**Summary and Analysis of Comments:
Control of Emissions of Air Pollution
from Locomotive Engines and Marine
Compression Ignition Engines Less than
30 Liters Per Cylinder**

**Chapter 4
Certification and Compliance Program**

Assessment and Standards Division
Office of Transportation and Air Quality
U.S. Environmental Protection Agency

**Variable-Pitch or Electronically-Coupled Engines
(shown for engine capable of operating on E3 cycle)
NTE Zone: Sub zones and FEL Multipliers**

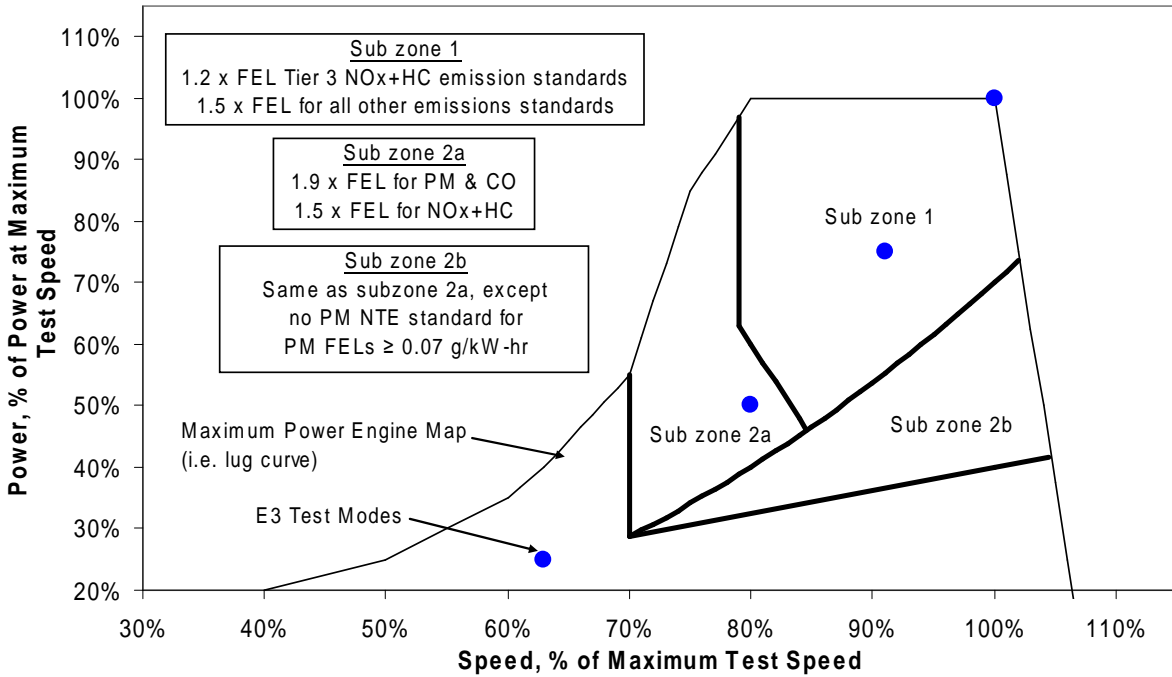
Caterpillar Inc. (Caterpillar) OAR-2003-0190-0485, 0498, 0580.1, 0591.1, 0822
Engine Manufacturers Association (EMA) OAR-2003-0190-0575.1

After the comment period, we continued to work with the marine engine manufacturers to better understand the unique characteristics of these engines. As discussed above, applications using variable-pitch or electronically-coupled engines vary greatly. In some applications, the engine may operate similar to a fixed pitch propeller engine and others more

similar to a constant speed engine. In addition, some engines may operate over a wide range of speed and loads more similar to a nonroad engine.

Although a single NTE zone is used for all variable-pitch or electronically-coupled engines, this zone varies in appearance by power curve. For an engine capable of operating over the E3 duty cycle, it approaches the NTE zone for nonroad engines. In this case, the NTE limits are based on a comparison to the E3 duty cycle results. For engines that are not capable of operating over the E3 duty cycle, and are better reflected by the E2 duty cycle, the NTE zone and limits approach those for constant speed engines. In this case, the NTE limits are based on a comparison to the E2 duty cycle results. The following two figures present the NTE zone and limits and give an indication of how the shape of the zone is affected by the power curve of the engine.
